**In the Drawings**

## **REMARKS**

Figure 1A  
(PRIOR ART)

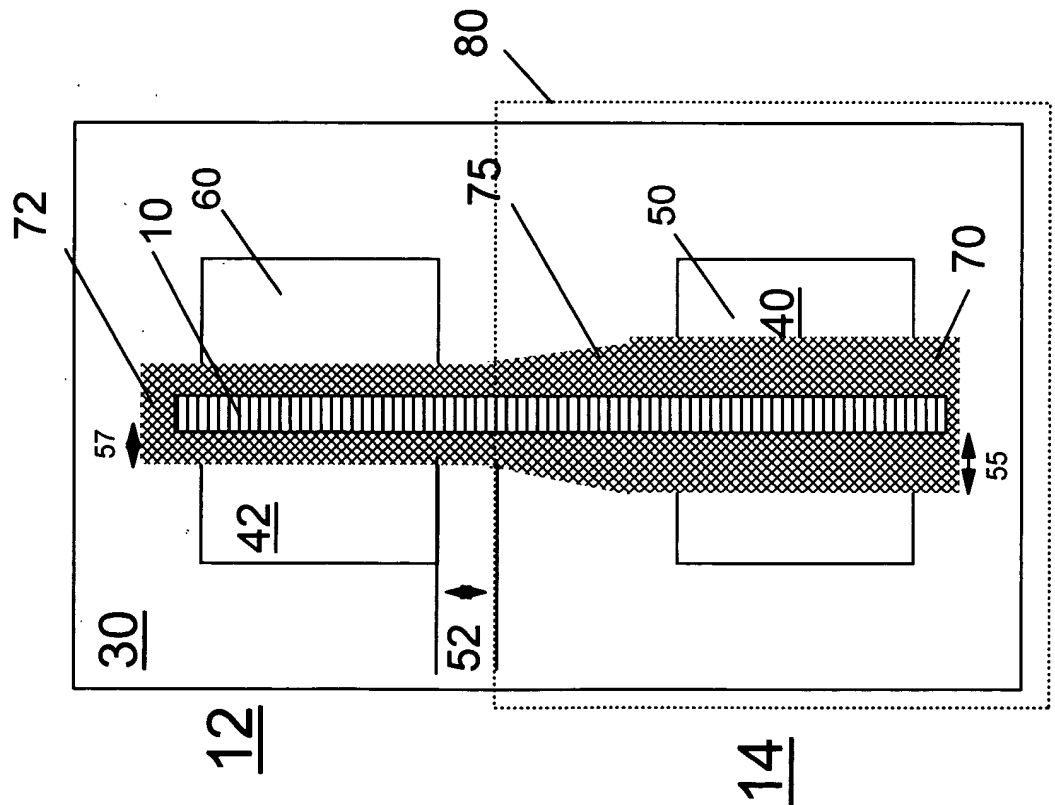
The objections to Figure 1A and claim 2 have been addressed herein by their amendment.

Please delete sheets numbered 1/12, 7/12, and 8/12 containing Figures 1A-1B, 7 and 8, respectively, and insert attached Replacement Sheets 1, 7 and 8.

Figure 7

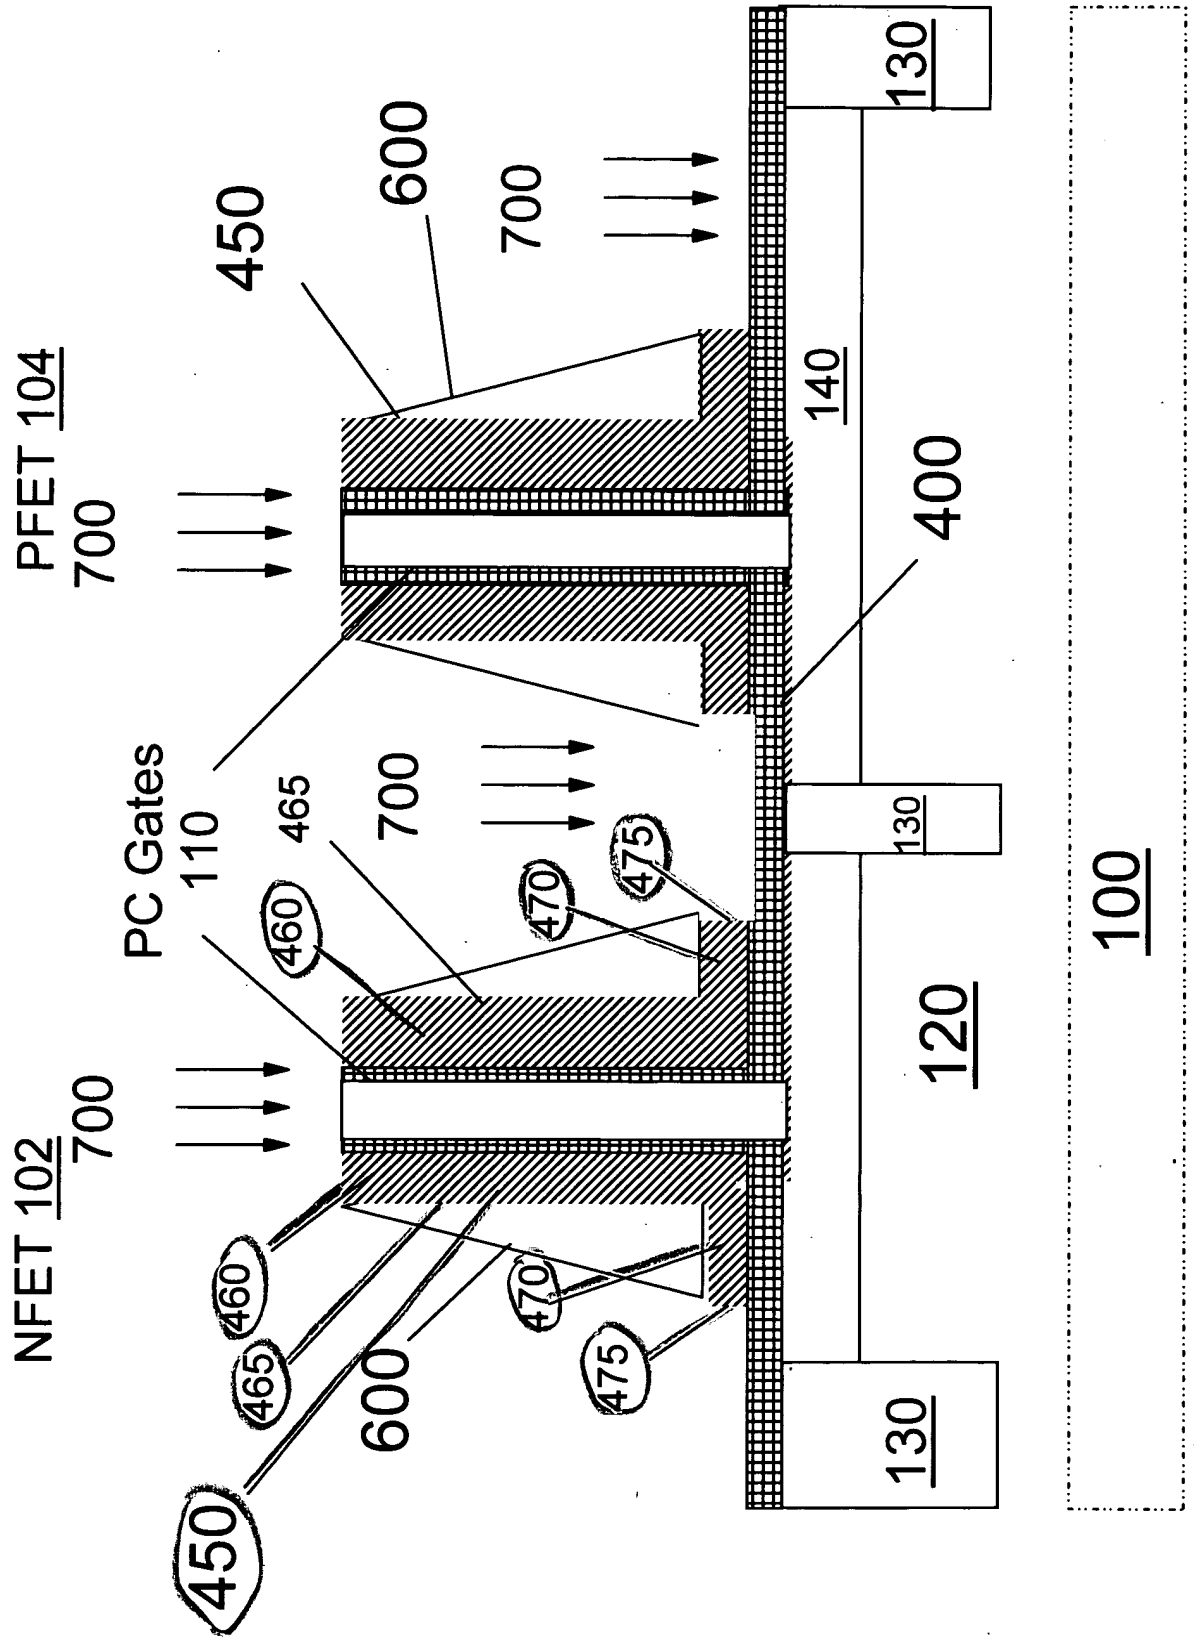
In addition, the specification and Figures 7 and 8 of the drawings are amended herein to add reference signs to features which appear in the original Figures and are supported by the original drawings and specification but were not specifically referenced before. A set of Replacement Sheets are submitted herewith together with a set of Annotated Sheets showing the changes made to the drawings. The specification is also amended accordingly. It is respectfully submitted that no new matter is contained in the present amendments.

As amended herein, claim 15 now specifies that the first spacers have an "L" shape. Being "L"-shaped, as shown in Figure 7 and as described in the specification, each first spacer includes a vertically extending portion oriented in a vertical direction,
